RE: BENNETTS GREEN BUNNINGS AND BULKY GOODS DEVELOPMENT

1. As requested, we are writing regarding matters raised by council and RMS in relation to the above development. We have previously prepared a report¹ which was submitted with the development application.
2. The council email of 27 September and RMS letters of 26 October 2017 include a number of traffic and parking matters. In response to the matters raised, amended plans have been prepared by the project architect. These matters, and our responses, are set out below.

**12.5m LARGE RIGID VEHICLE
 SWEEP PATHS**

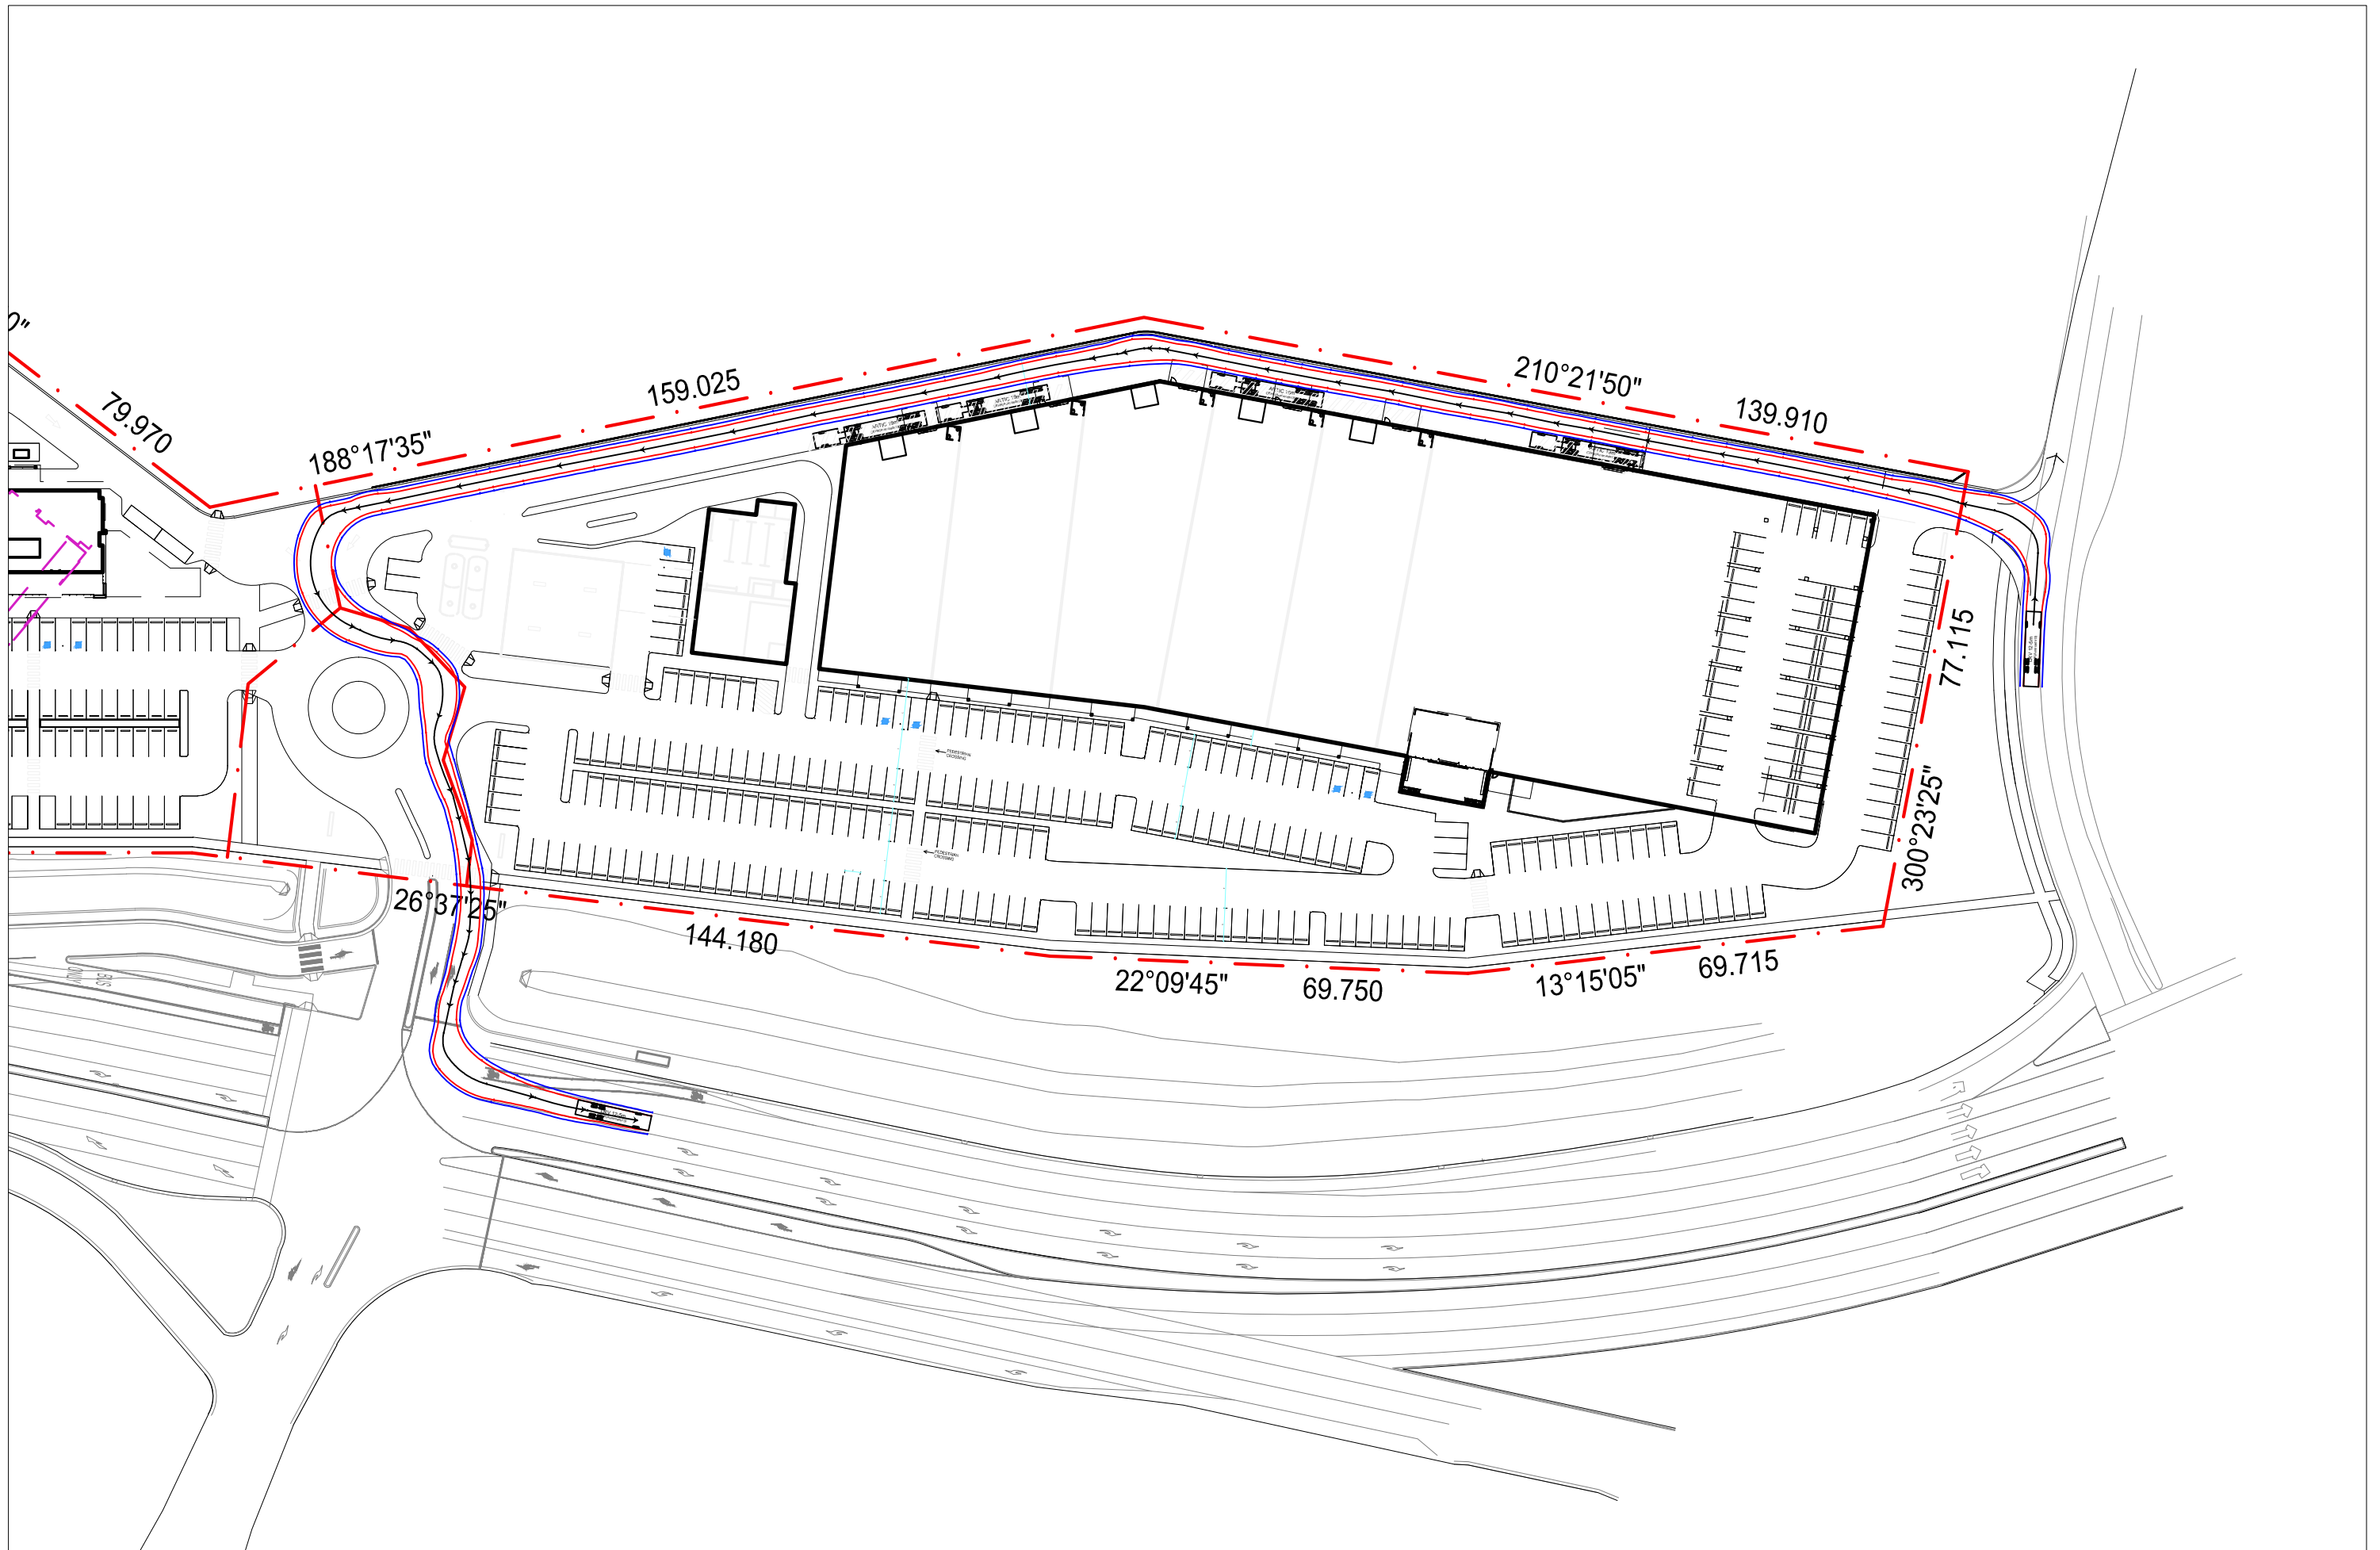
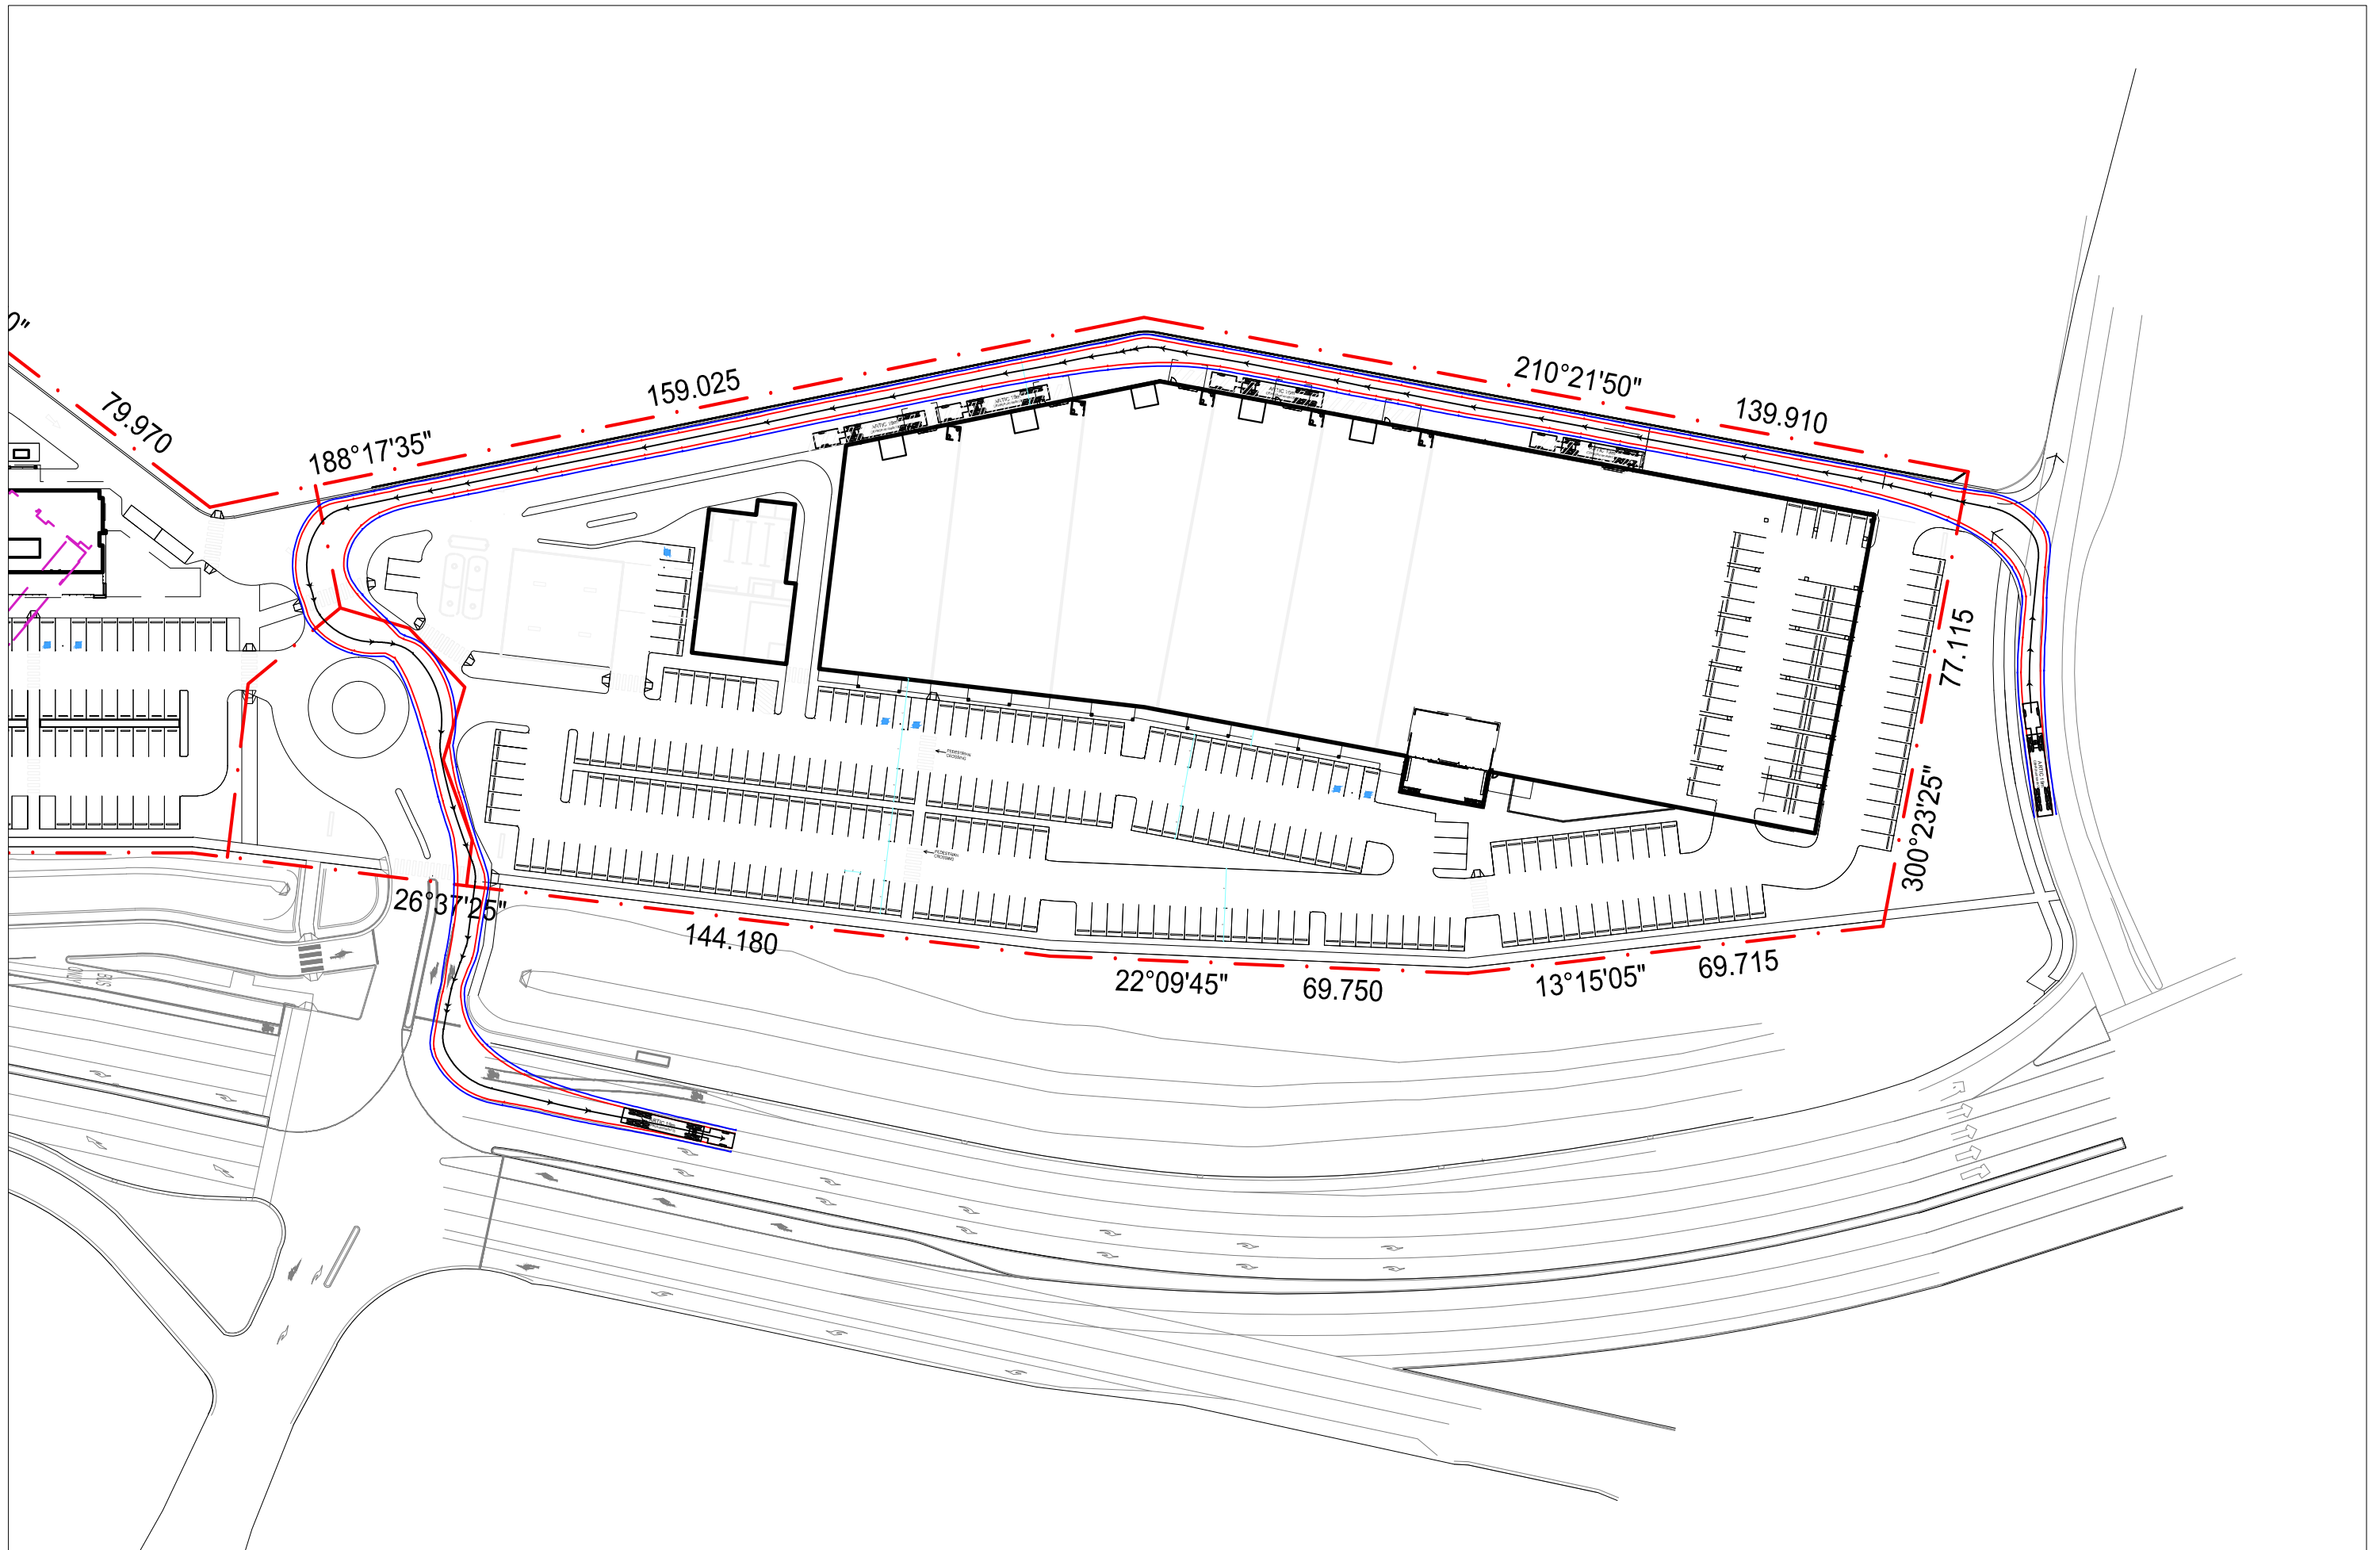
6. The proposed arrangements are therefore considered to be appropriate.
 - *Building Products Warehouse and Showroom*
 - 1) *The access ramp/driveway from South Street to the rear service bay of the Building Products Warehouse and Showroom requires additional detail in the form of widths, clearances and the like, inclusive of swept paths from South Street, through the access ramp and within the service delivery bay...*

- *Servicing*
 - 1) *Details of service vehicles including swept paths are required for internal areas (deliveries and waste collection) for the Building Products Warehouse & Showroom as well as the Bulky Goods Units and Restaurant. Additionally movements at the (Bunnings service vehicles) South Street and the Pacific Highway access points are to be provided.*

- *Details for servicing (deliveries & waste collection) the development are required in terms of manoeuvring/swept paths.*

7. Vehicle swept paths are attached to this letter as Figures 1 to 12.
 - *Parking*
 - 1) *The development provides a total 846 car parking spaces, 13 additional non-discriminatory parking spaces and 2 waiting bays. An assessment based on the proposed GFA identified 697 car parking spaces and 14 non-discriminatory parking spaces as being required. Therefore as an excess in car parking is proposed a reduction is required as per Council's DCP and to improve landscaped outcomes.*

21. Service vehicle swept paths are shown in Figures 1 to 12.

- *The plans are ambiguous as to how vehicles will access the Take Away Food & Drink Premises. It appears vehicles are required to access the drive thru via the entrance of the Service Station, which could become quite congested considering queuing for petrol bowsers. Details are required on how vehicles will access the drive thru and what will prohibit these vehicles travelling on the Service Road in the opposite direction to Service Vehicles.*

16. Vehicles will enter this drive-through from the service station, in a similar manner to many other service station/fast food developments. The swept paths attached in Figure 12 show that with two vehicles queued at the petrol bowers, other vehicles will be able to readily circulate to the drive-through.
17. There will be appropriate no entry signage at the western leg of the roundabout, which will apply to service vehicles and general traffic.
